dsPIC33EPXXXGP50X, dsPIC33EPXXXMC20X/50X and PIC24EPXXXGP/MC20X Family Silicon Errata and Data Sheet Clarification

The dsPIC33EPXXXGP50X, dsPIC33EPXXXMC20X/50X and PIC24EPXXXGP/MC20X family devices that you have received conform functionally to the current Device Data Sheet (DS70000657H), except for the anomalies described in this document.

FIGURE 1: TIMING DIAGRAMS FOR CENTER-ALIGNED AND EDGE-ALIGNED MODES

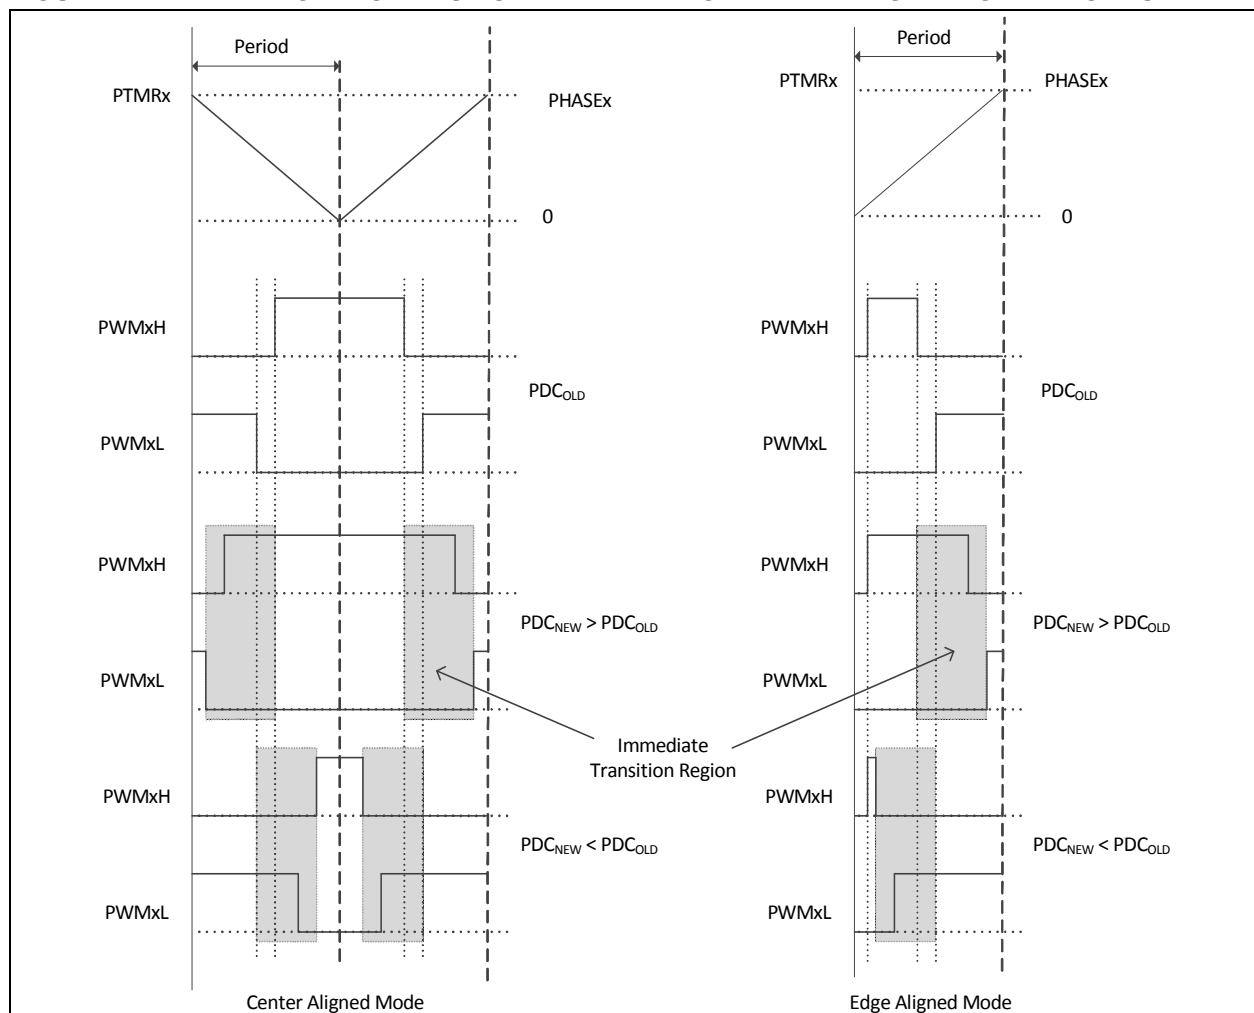
The PWM generator may not assert dead time on the edges of transitions. This has been observed when all of the following conditions are present:

- The PWM generator is configured to operate in Complementary mode with Independent Time Base (ITB) or master time base;
- Immediate update is enabled; and
- The value in the PDC register is updated in such a manner that the PWMxH and PWMxL outputs make an immediate transition.

In [Figure 1](#), if the duty cycle write occurred in the shaded box, then PWMxH and PWMxL will make an immediate transition without dead time.

However, in most applications the duty cycle update timing can be controlled using the TRIGx trigger, or Special Event Trigger, such that the above mentioned conditions are avoided altogether.

FIGURE 2: PWM TIMING DIAGRAM

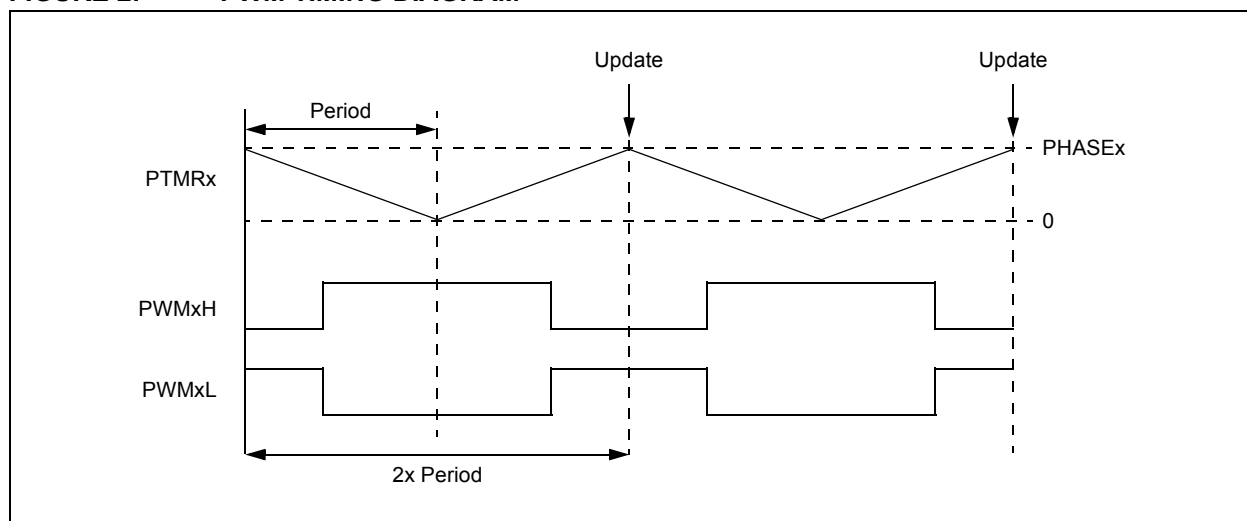
In Center-Aligned mode, updates to active MDC/PDCx/ALTDTRx/PHASEx registers occur only once every two PWM periods; that is, when the PWM timer matches the PHASEx register. In other words, the double update feature is not available. Figure 2 illustrates this relationship.

FIGURE 3: CORRECT AND INCORRECT POSITION COUNT CAPTURES

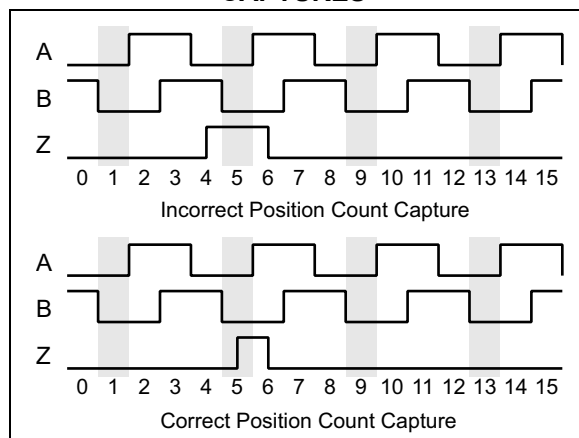
When index count position capture is being used (QEIXIOC.QCAPEN = 1), the position count may be one more or one less than the correct value, depending on the direction of the count.

This is only observed when the leading edge of the index pulse occurs prior to the leading edge of the index match event. When the index pulse starts after the leading edge of the index match event, the position count is captured correctly.

Figure 3 shows how this occurs. In these cases, Encoder Signals A, B and (index) Z are shown, with the module being configured for index match when A and B are '0'. The effects of a correct and incorrect capture are shown side by side (shaded area indicates the index match event); the position count is shown along the bottom.

For encoder signals with timing that ensures the index pulse always starts prior to the start of the index match event (i.e., encoders with a non-gated index pulse), measure the direction of the encoder motion. If the encoder is counting up, add one to the captured position count; if the encoder is counting down, subtract one from the captured position count.

For encoder signals where the index pulse leading edge approximately coincides with the start of the index match event (i.e., encoders with a gated index pulse), a small delay can be added to the index pulse, for instance, by using a simple R-C filter.

FIGURE 4: PWM GENERATOR TIMING DIAGRAM**Work around**

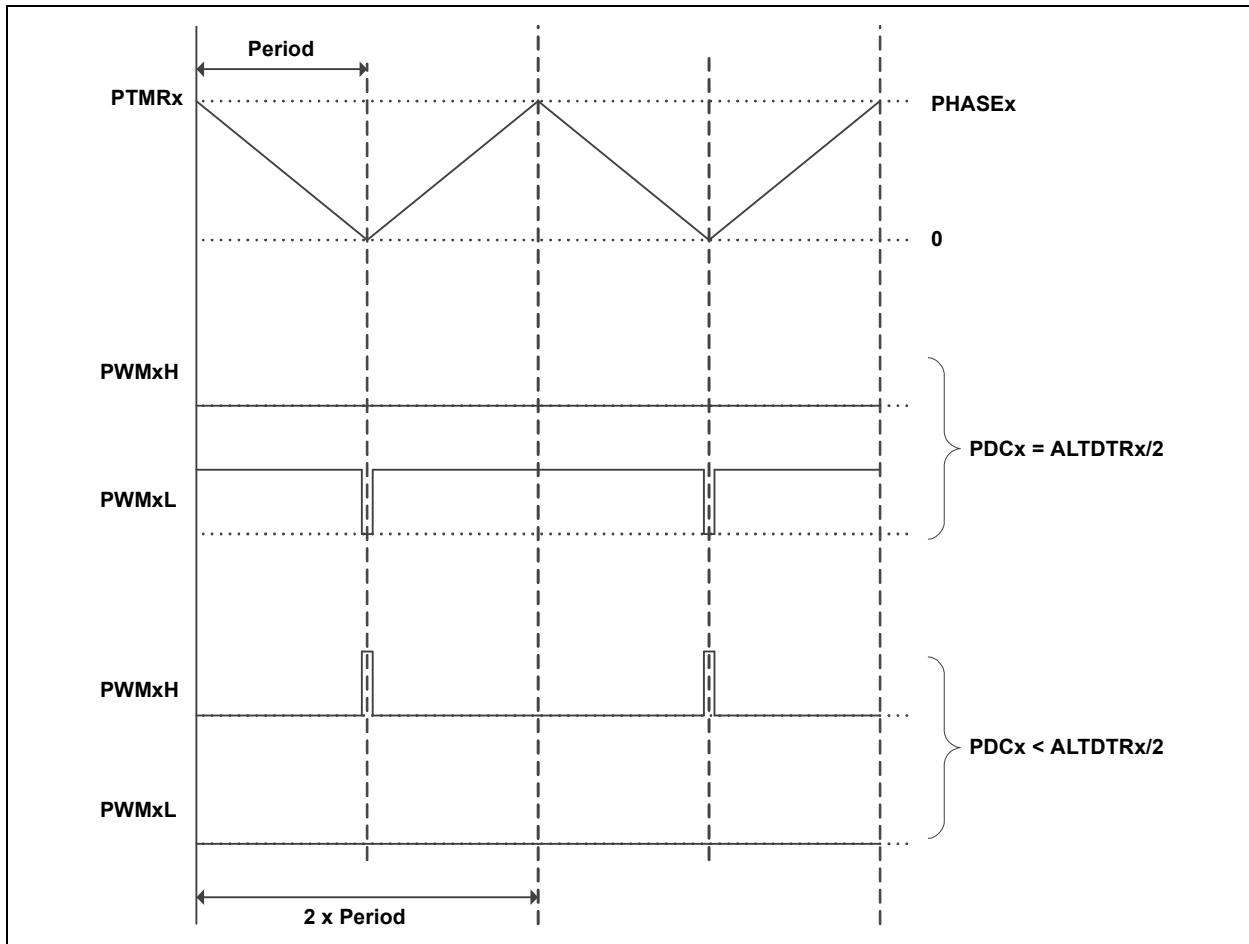
In Center-Aligned Complementary mode with Independent Time Base, if the value in the PDCx register is less than one-half the value in the ALTDTRx register, the PWM generator will force the PWMxL to low, and on the PWMxH, generate pulses of width less than twice the dead time, as shown in Figure 4.

Include a software routine to ensure that the duty cycle value written to the PDCx register is always at least one-half of the value in ALTDTRx. Example 3 shows one method, with PDCtemp representing the variable which has the value to be written to the PDCx register. Alternatively, for duty cycle values less than half the desired dead time value, zero out the ALTDTRx register or dynamically reduce the value in the ALTDTRx register, such that ALTDTRx is always equal to 2 * PDCx, as shown in Example 4.

FIGURE 5: ILLUSTRATION OF 1 T_{osc} GLITCH WHEN PWM OVERRIDE IS TURNED OFF

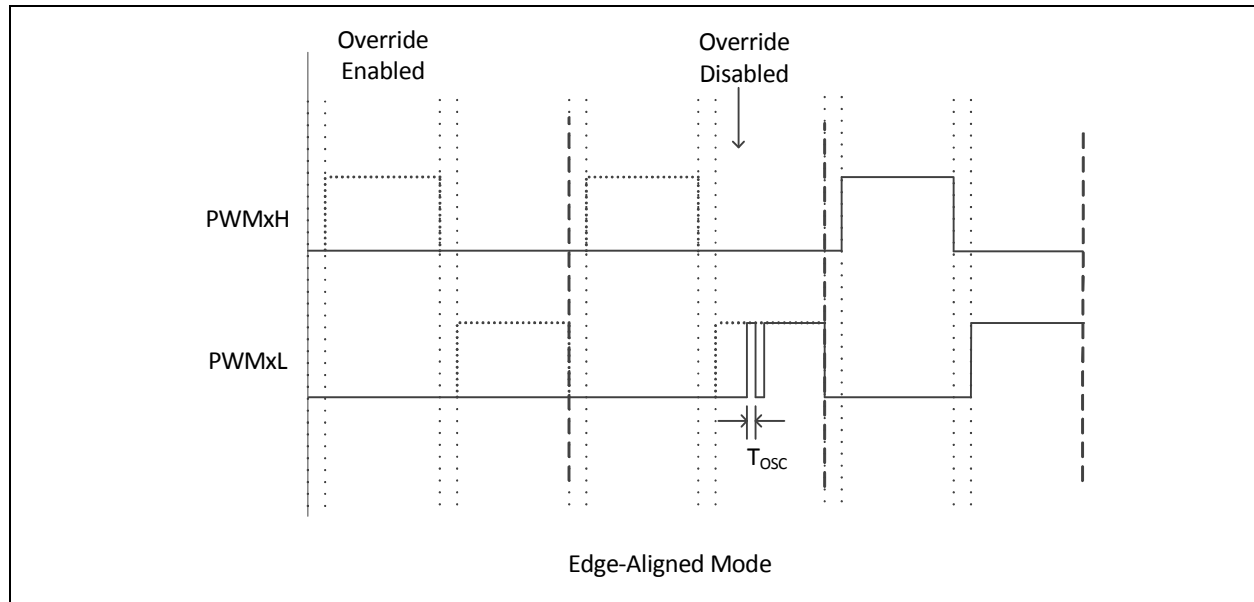
In Complementary mode after the PWMx module is enabled (PTEN = 1), if the PWM override is turned off, a 1 T_{osc} glitch will be present on the rising edge of either PWMxH or PWMxL, whichever occurs first, as shown in Figure 5. The glitch will be present on PWMxH/PWMxL every time the override state is changed from enabled to disabled. The width of this glitch is equal to 1 T_{osc} when PCLKDIV<2:0> = 000; increasing the PWM input clock prescaler setting will increase the width of the glitch accordingly.

FIGURE 6:

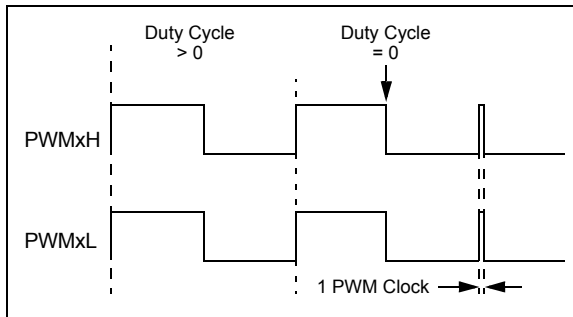
In certain output modes, the PWMx module produces a pulse glitch of one PWM clock in width (Figure 6). This has been observed only when all of the following are true:

- Either Redundant or Push-Pull Output mode is selected ($\text{IOCONx}<11:10> = 10$ or 01);
- Immediate Update is disabled ($\text{PWMCONx}<0> = 0$); and
- The value of the current Duty Cycle register (either the PDCx or MDC register, as determined by $\text{PWMCONx}<8>$) is updated to zero from any non-zero value.

The pulse glitch has been observed to occur at the beginning of the following PWM boundary period.

FIGURE 7:

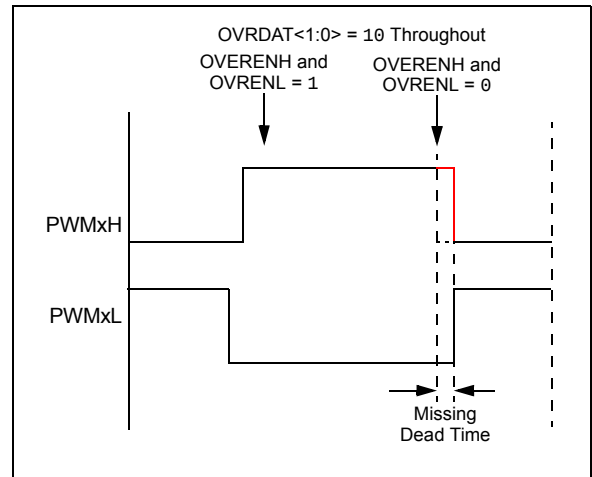
- Output override synchronization is configured to occur on the CPU clock boundary ($\text{IOCONx}<0> = 0$);
- Both PWMxH and PWMxL overrides are enabled prior to the event (OVRENH and OVRENL are both '1'), and
- Both overrides are disabled (OVRENH and OVRENL are both '0') at the instant the dead time should be asserted (Figure 7).

This has been observed in both Center-Aligned and Edge-Aligned modes.

FIGURE 8:

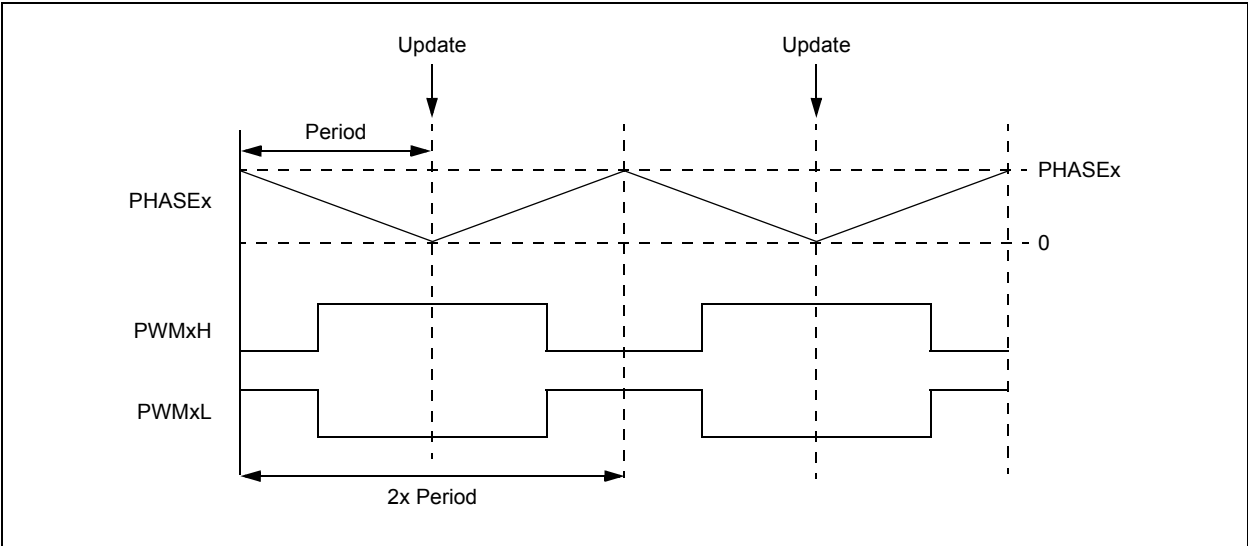
In Center-Aligned Complementary mode with Independent Time Base, updates to the PHASEx register take effect in the middle of a center-aligned PWM cycle, as shown in Figure 8. This occurs only when the Immediate Update feature is disabled (IUE = 0). If Immediate Update is enabled (IUE = 1), the PHASEx register updates will take effect immediately.

FIGURE 9: SIMPLIFIED BEHAVIOR

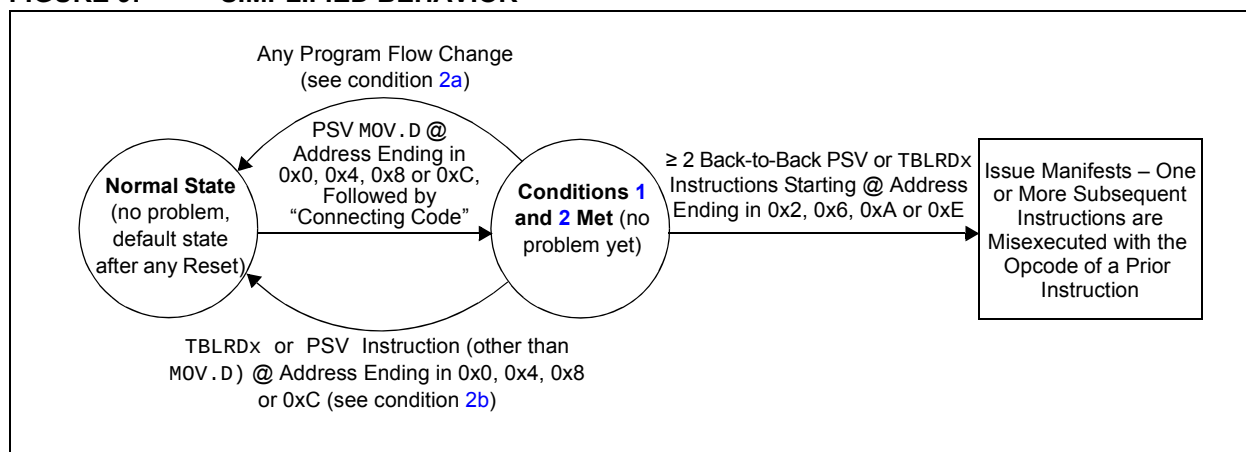
3.	≥ 2 back-to-back PSV or TBLRDx instructions are executed (following the code of condition 2), where the first of the back-to-back instructions is located at an address ending in 0x2, 0x6, 0xA or 0xE.

[Figure 9](#) provides an example of the effective behavior.

1. All instances of PSV MOV.D can be replaced with two PSV MOV instructions instead. Non-PSV MOV.D instructions acting on RAM/SFRs do not need to be modified; or
2. If not already present, a program flow change instruction (such as BRA \$+2) can be inserted above back-to-back data Flash read sequences; or
3. Back-to-back data Flash read instruction sequences can be broken up by inserting a non-Flash read instruction (such as a NOP) in between the Flash read instructions; or
4. The alignment of the code can be shifted to avoid the required opcode location addresses.

C code built with MPLAB® XC16 Compiler, Version 1.32, or later, implements the work around by default. However, if the application uses Assembly language routines, these should be manually modified to implement the work around. Additionally, if precompiled libraries are used, these should be built with XC16 Version 1.32 or later. For additional information, please visit: www.microchip.com/erratum_psrds_psrds.

FIGURE 32-10: TYPICAL LPRC FREQUENCY @ $V_{DD} = 3.3V$

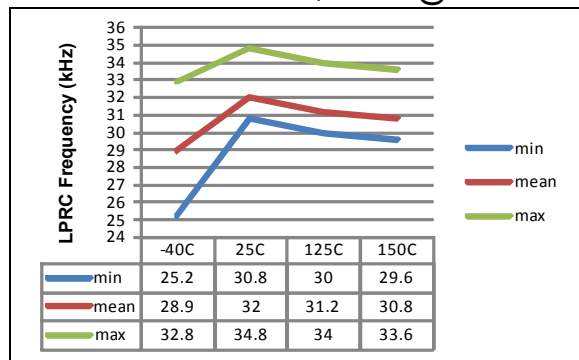
The typical LPRC frequency plot over temperature at $V_{DD} = 3.3V$ has been corrected, as shown in Figure 32-10 below.

FIGURE 25-1: OP AMP/COMPARATOR x MODULE BLOCK DIAGRAM (MODULES 1, 2 AND 3)

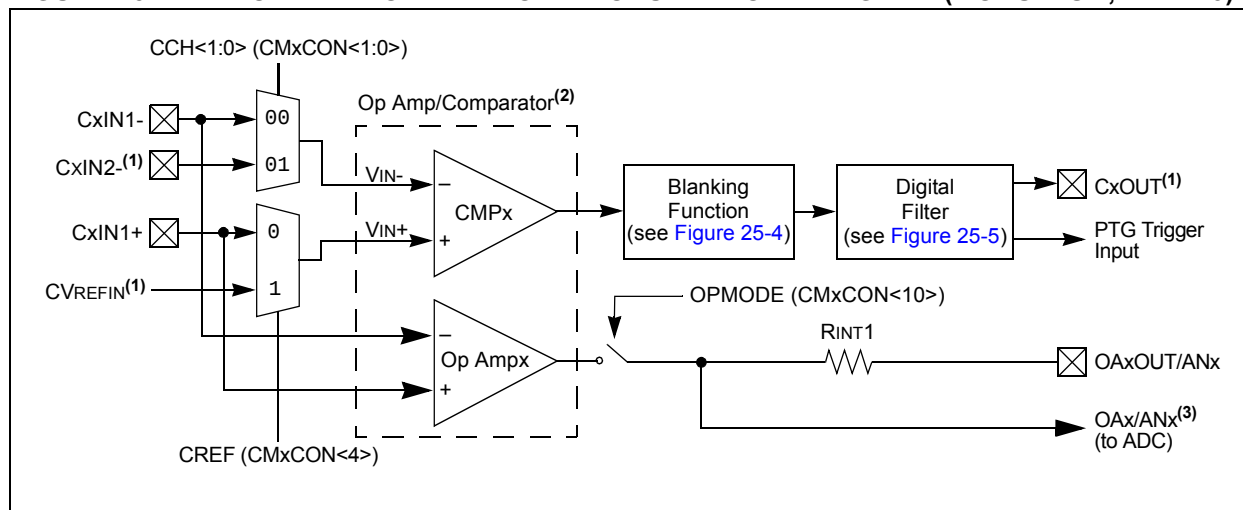
Figure 25-1 (shown below) is corrected to show that the op amp in these modules obtains its inverting and non-inverting inputs directly from the $\text{CxIN1-}/1+$ pins. The operation of the actual module is unchanged. (Footnotes in the original are unchanged, but are removed here for clarity.)
